Addendum 1 for RFB 950100-01

Project Name: DOC NCCF AHU & Condenser Replacement Unit A&B

RFB #: 950100-01

Addendum No. 1 Items:

SHEET INFORMATION	
Issue	100% CD
Date	4/29/2026
Project #	26001283.00
Drawn	EJH
Checked	NKJ
Approved	NKJ
SHEET TITLE	
HVAC COVERSHEET	
SCALE	
Scale:	As indicated
SHEET NUMBER	
M000

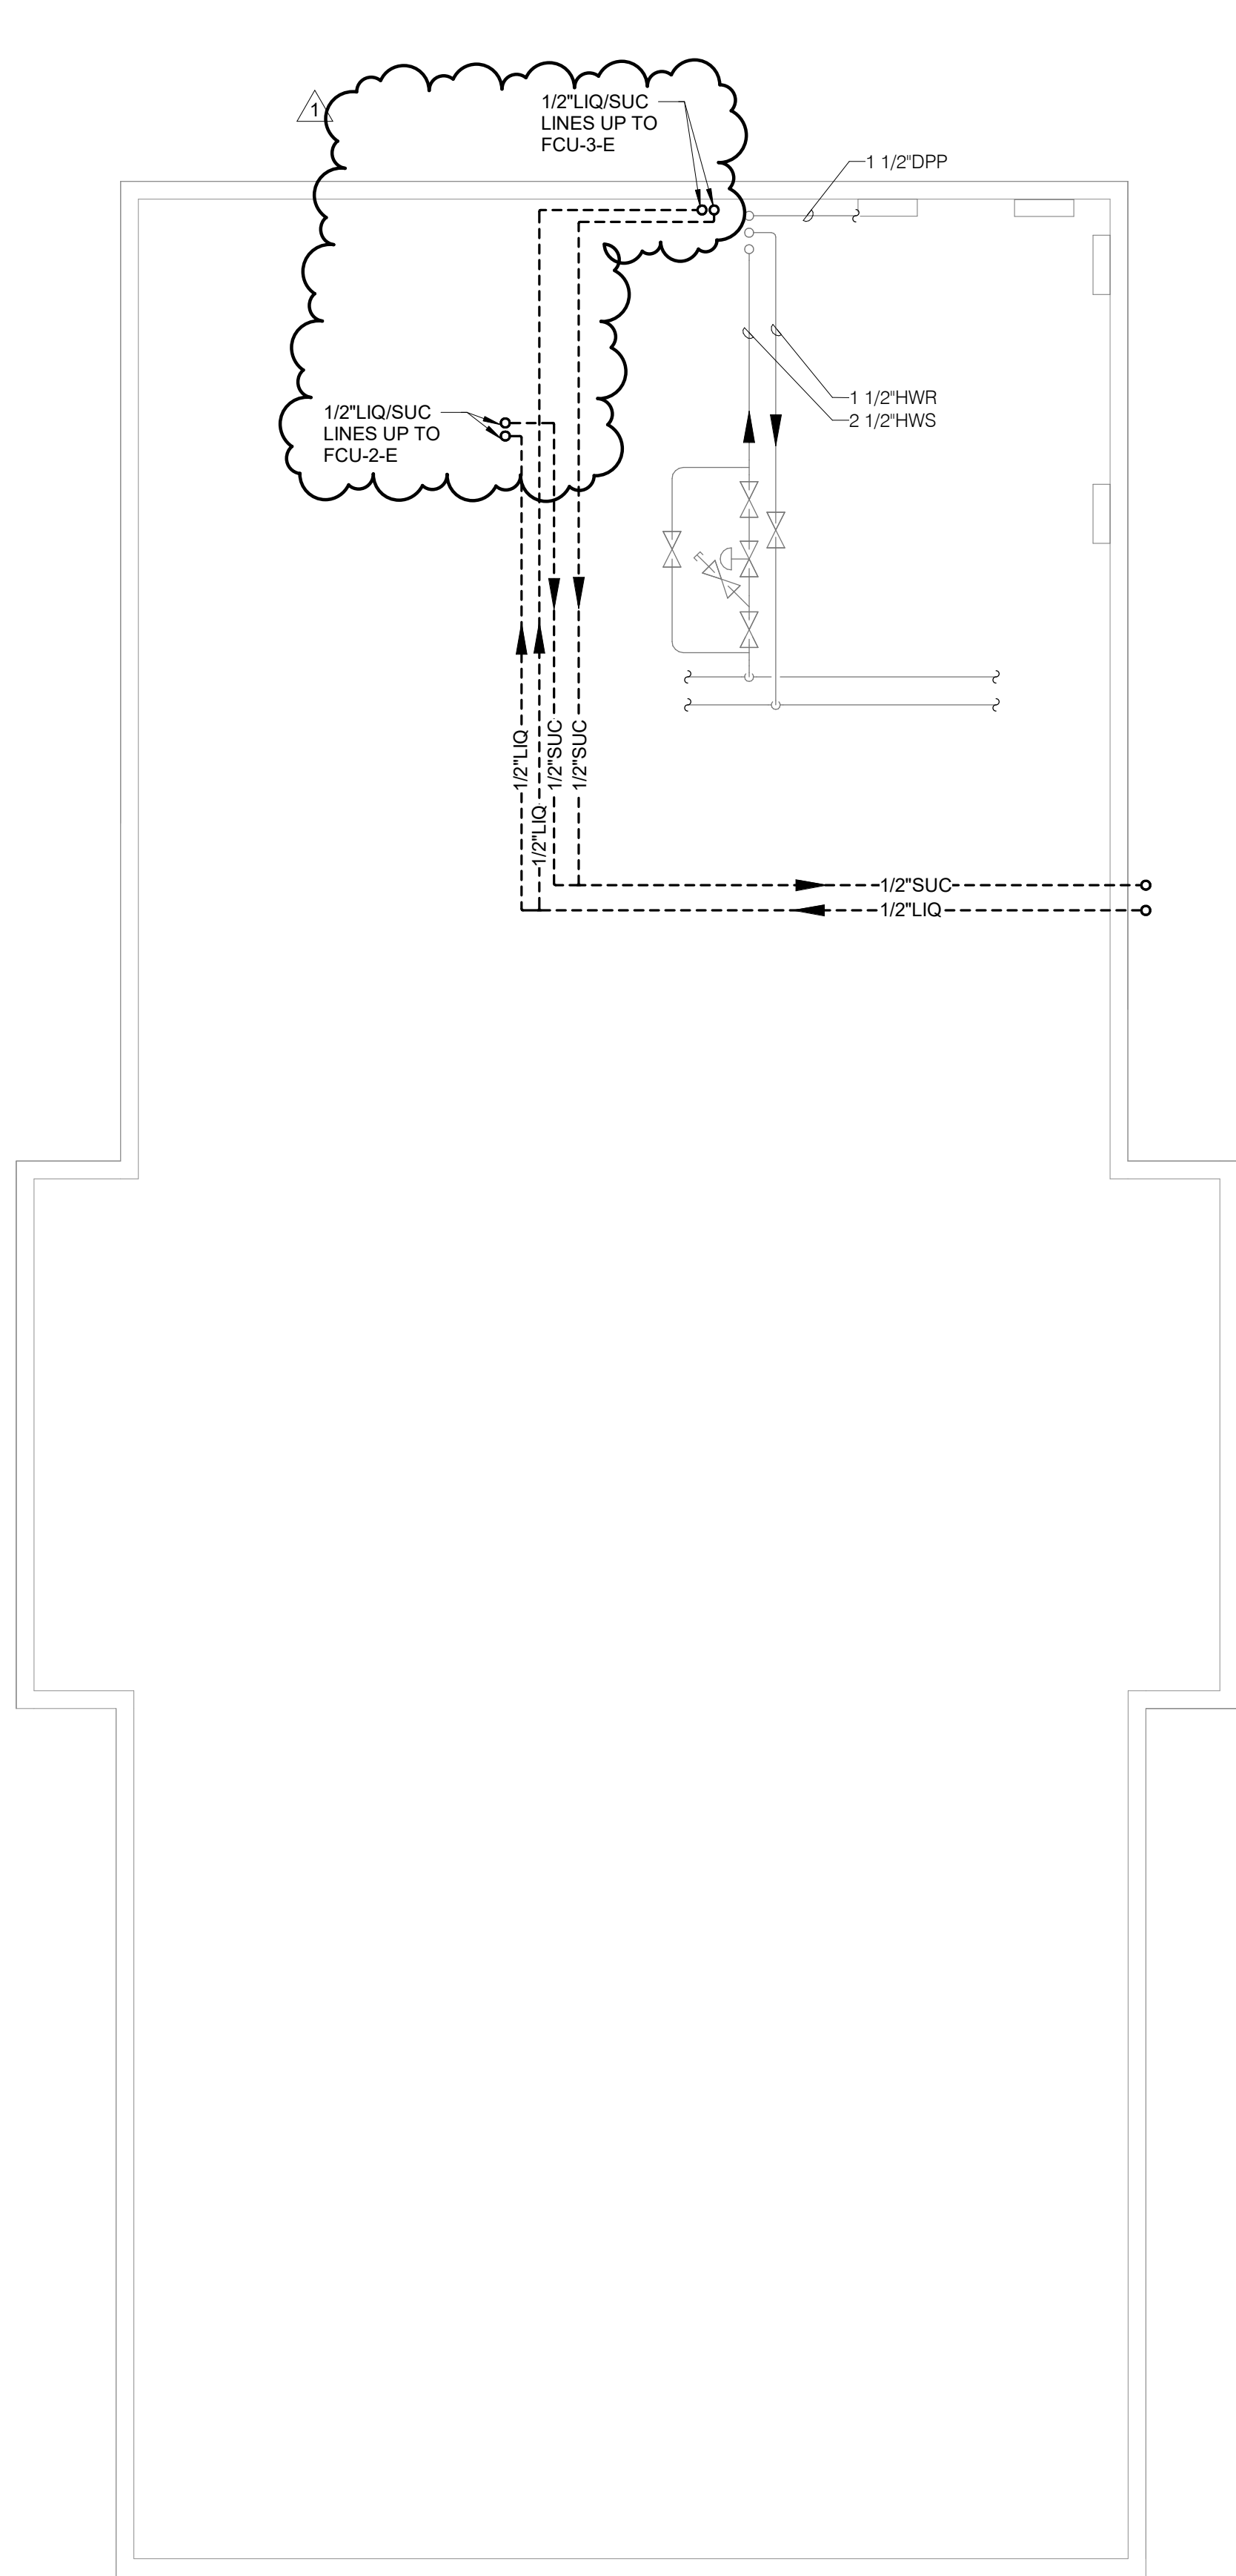
5. Drawing M000: HVAC COVERSHEET
 - i. ADD LPC and LPS to HVAC Abbreviation Key.
6. Drawing M100: BASEMENT DEMOLITION PLAN - HVAC
 - i. REVISE existing refrigerant pipe routing.
7. Drawing M101: LEVEL 01 DEMOLITION PLAN - HVAC
 - i. REVISE existing refrigerant pipe routing.
8. ADD refrigerant piping routed to FCU-2-E.
 - i. Drawing M102: LEVEL 02 DEMOLITION PLAN - HVAC
9. REVISE existing refrigerant and steam pipe routing.
 - i. ADD Keynote 2.

M210

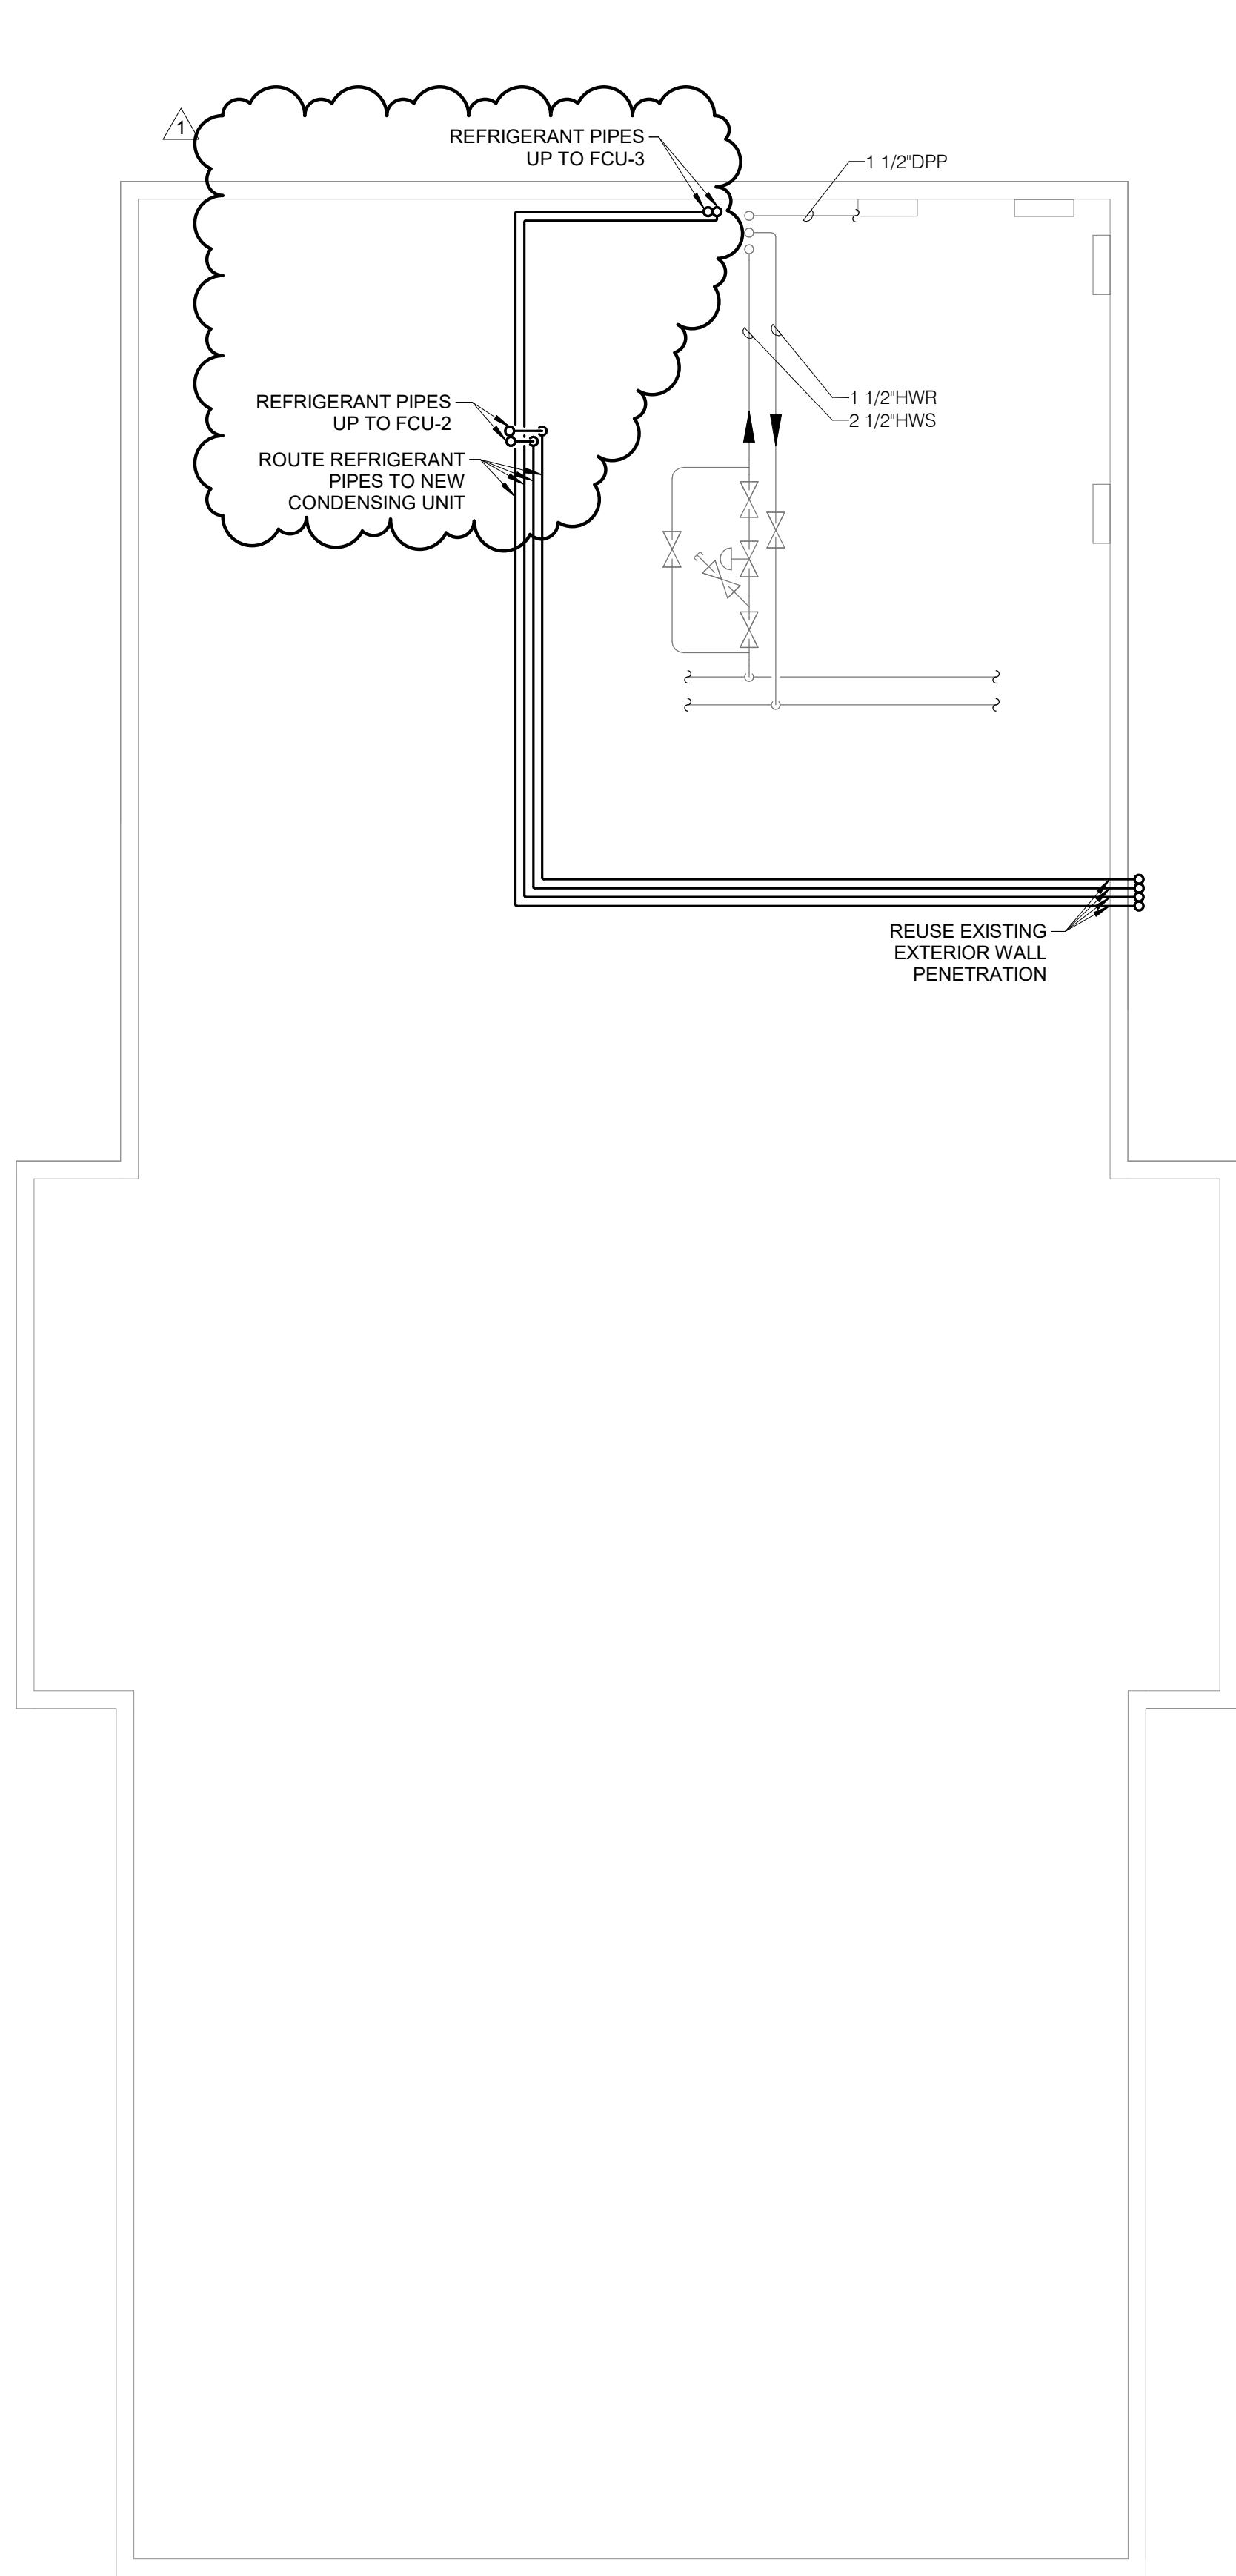
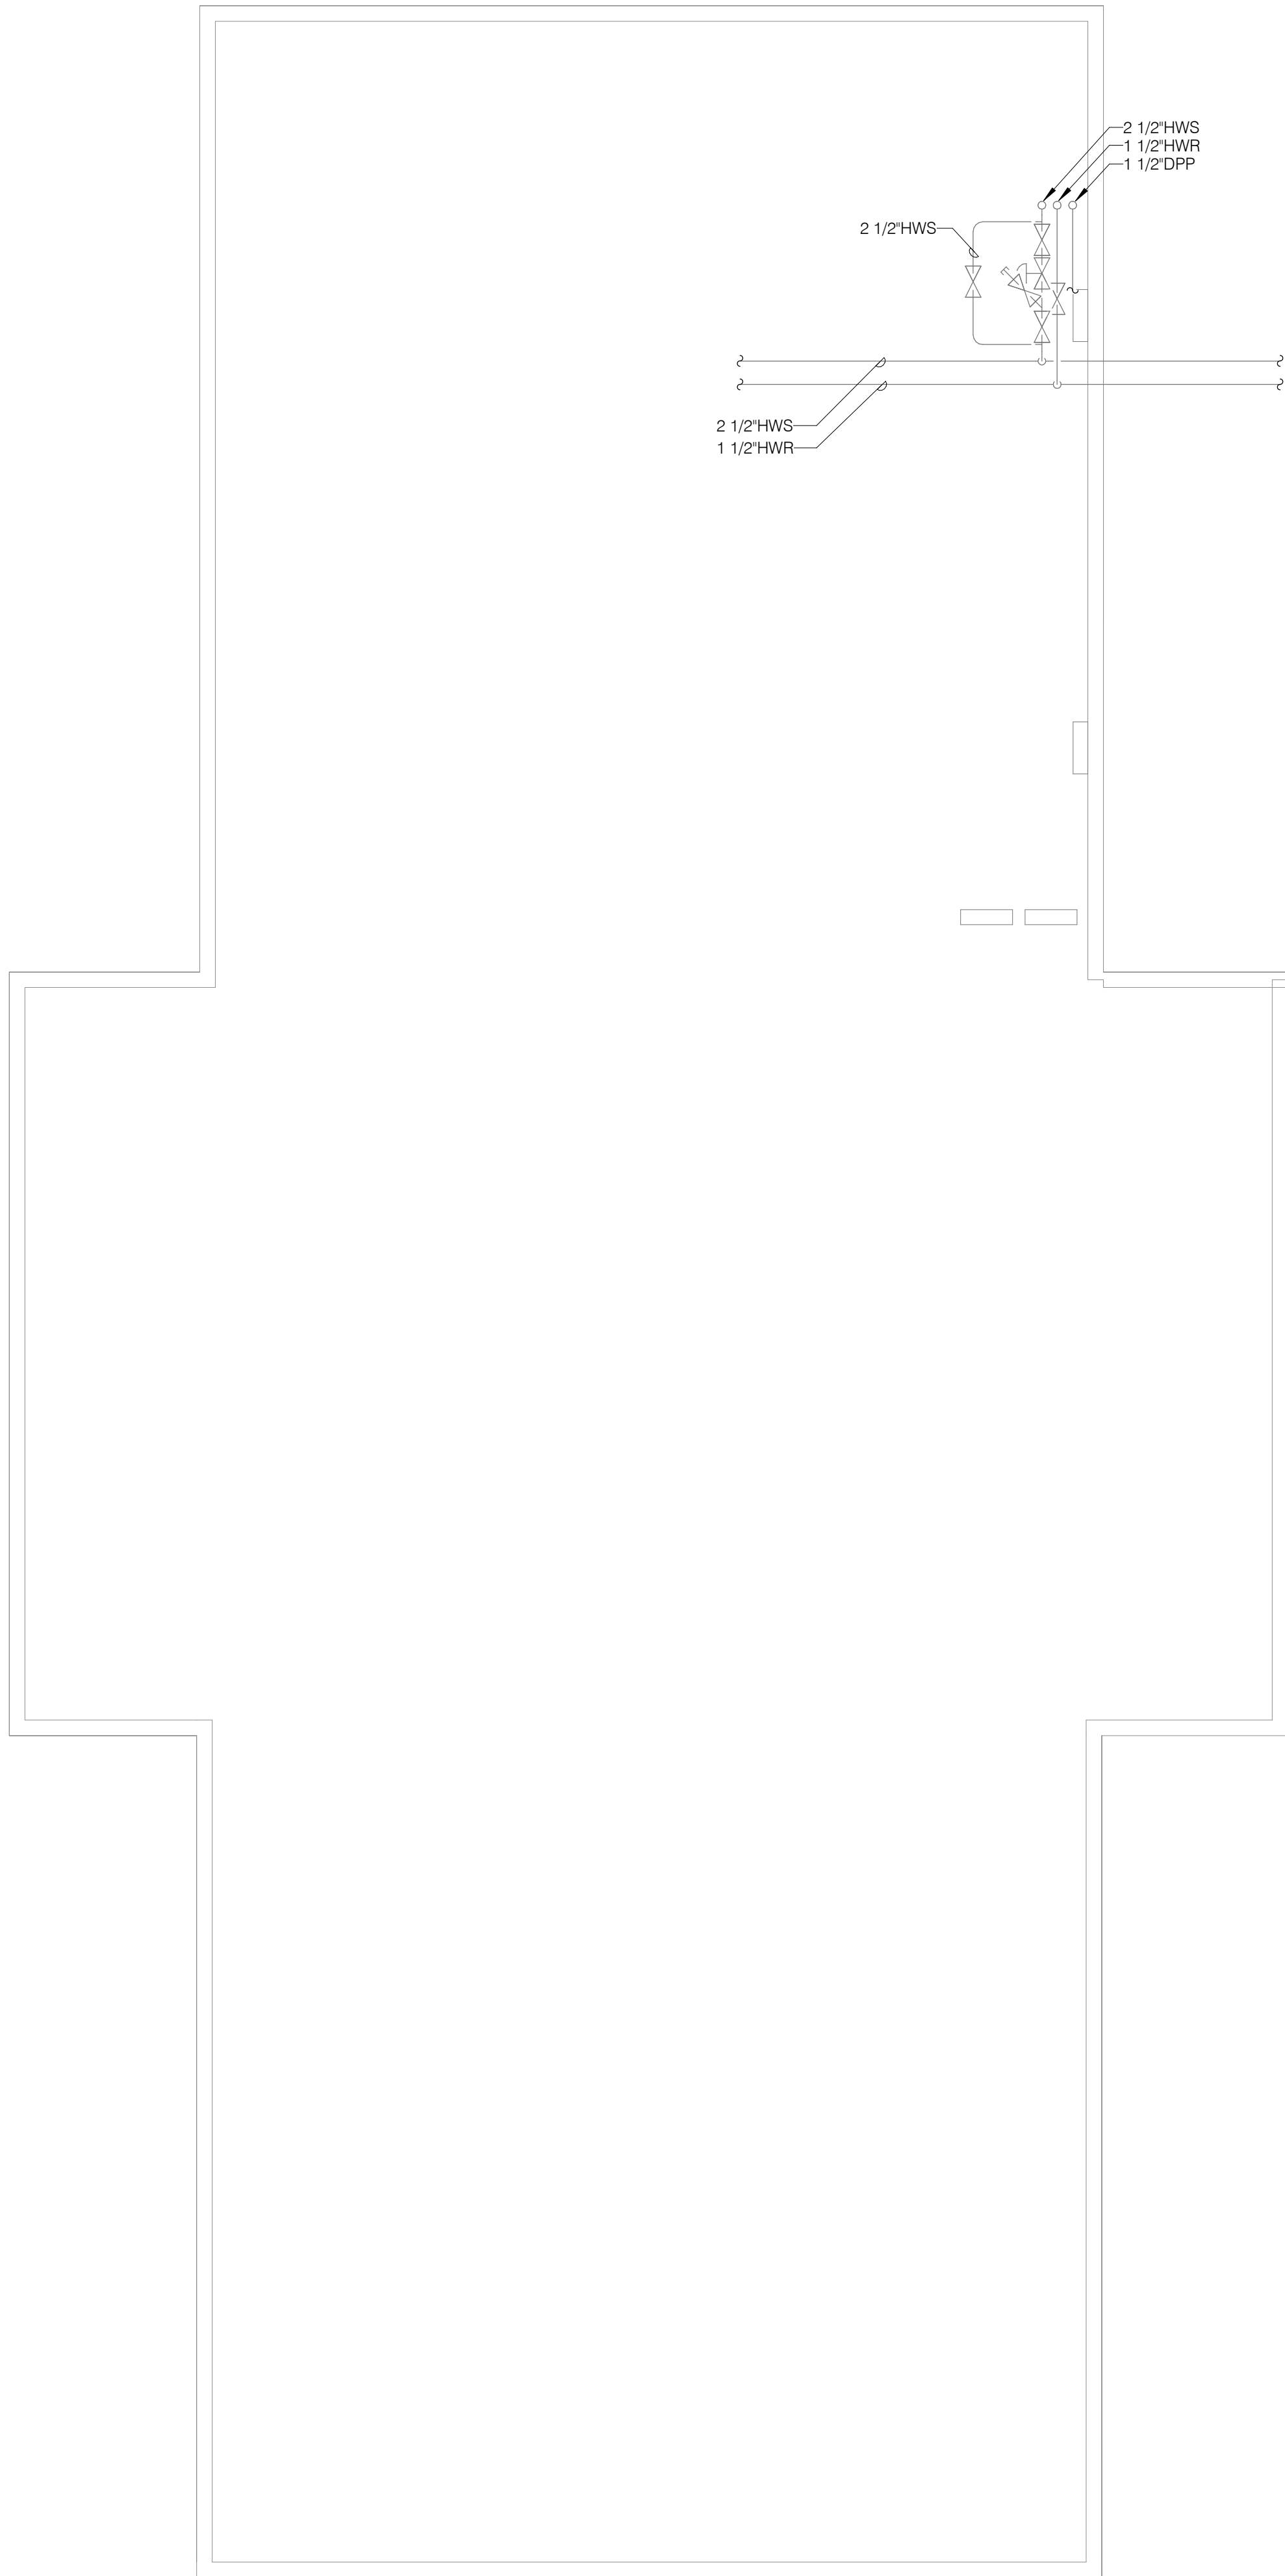
10. Drawing M210: BASEMENT PLAN - VENTILATION
 - i. REVISE new refrigerant pipe routing.
11. Drawing M211: LEVEL 01 PLAN - VENTILATION
 - i. REVISE new refrigerant pipe routing.
12. Drawing M 212: LEVEL 02 PLAN - VENTILATION
 - i. REVISE new refrigerant and steam pipe routing.
 - ii. ADD Keynote 5.
13. Drawing M500: HVAC SCHEDULES
 - i. REVISE Fan coil unit control diagram detail 1.
